RE: **Lot 2 Block 4 Volcano Cliffs Unit 19 SAD 228**
6552 Azor Lane NW
Grading and Drainage Plan
Engineers Stamp Date 12/5/2022 (D10D003T4)
Pad Certification Date 2/13/2023

Based upon the information provided in your submittal received 3/10/2023, this plan is approved for building permit.

ENGINEER'S SEAL	LOT 2 BLK 4 U 19 VC 6552 AZOR LANE GRADING AND DRAINAGE PLAN  <i>Rio Grande Engineering</i> PO BOX 93624 ALBUQUERQUE, NM 87199 (505) 321-9099	DRAWN BY DEM
 12/5/22 DAVID SOULE P.E. #14522		DATE 12-3-22
		Lot 2 Blk 4 Un 19 VC.DWG
		SHEET # C1
		JOB # _____

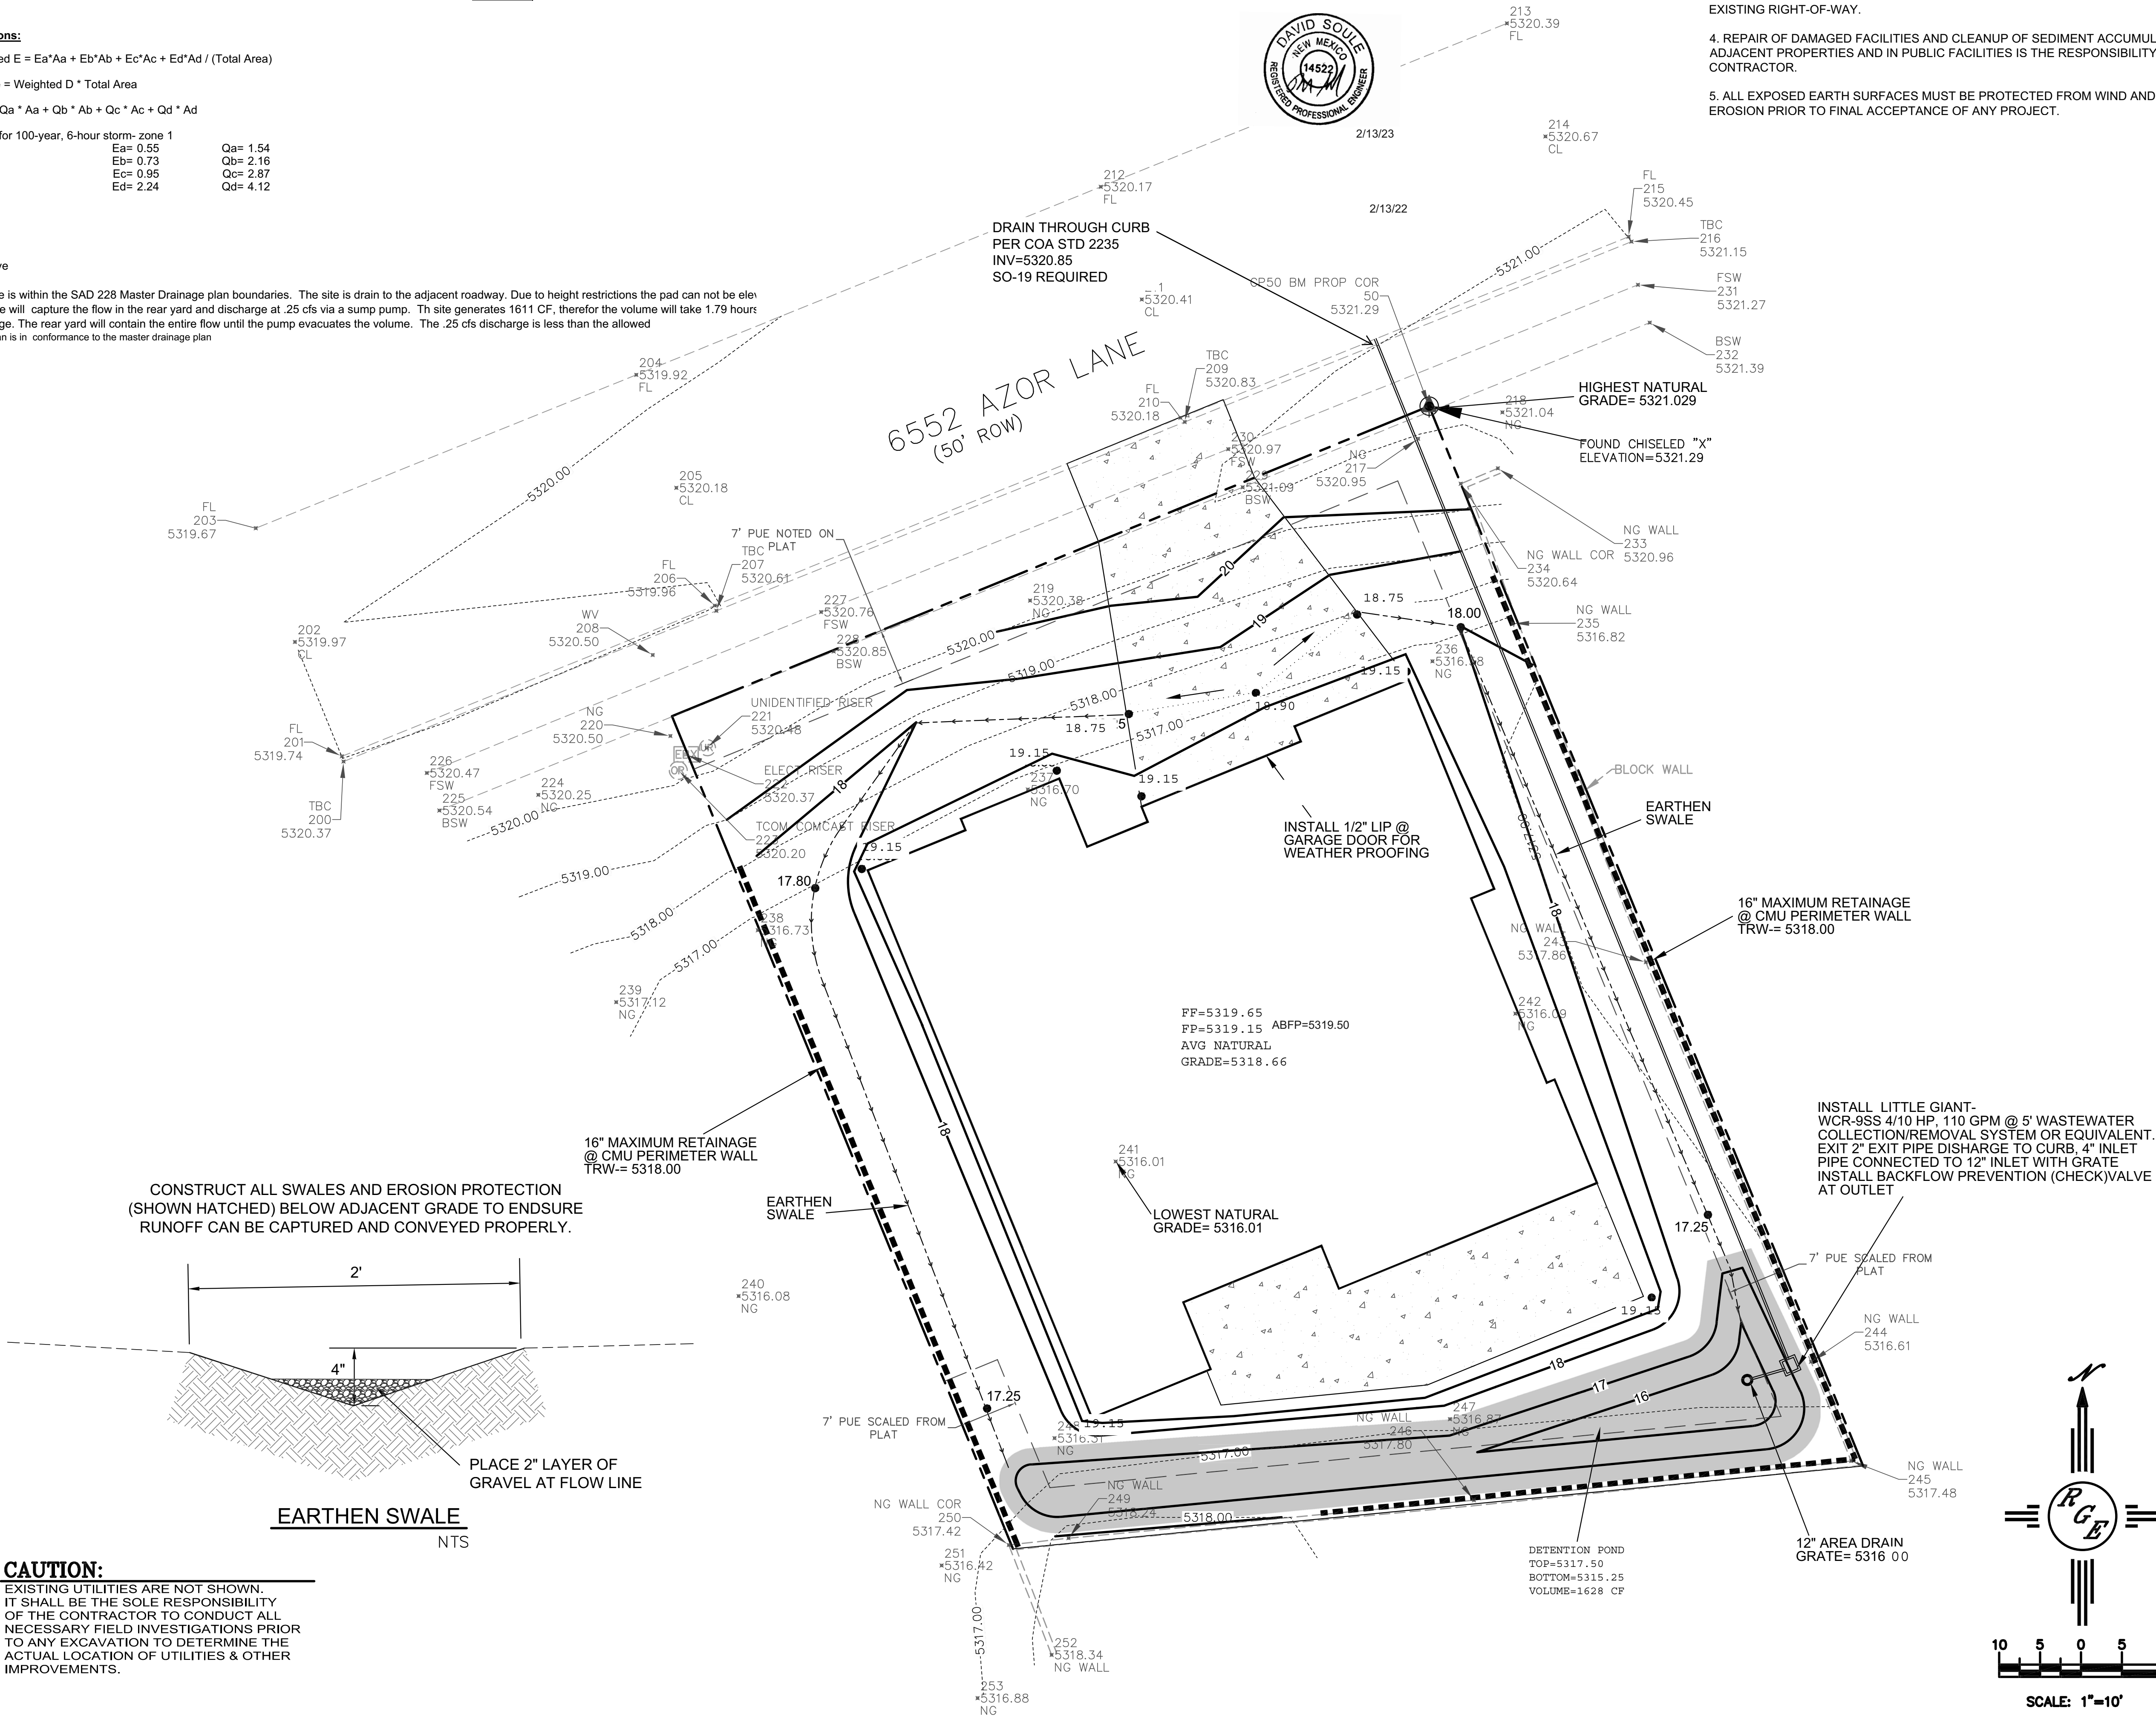
Reiterate to the Owner/Contractor that a separate permit for a garden/retaining wall must be obtained, with the approved G&D plan and Pad Certification. Advise the owner & Contractor that dirt is not allowed in the public right of way to climb the curb. Crusher fines or lumber is allowed. If dirt is used this will delay going forward with the construction of the home.

Prior to Certificate of Occupancy release, Engineer Certification per the DPM checklist of this plan will be required.
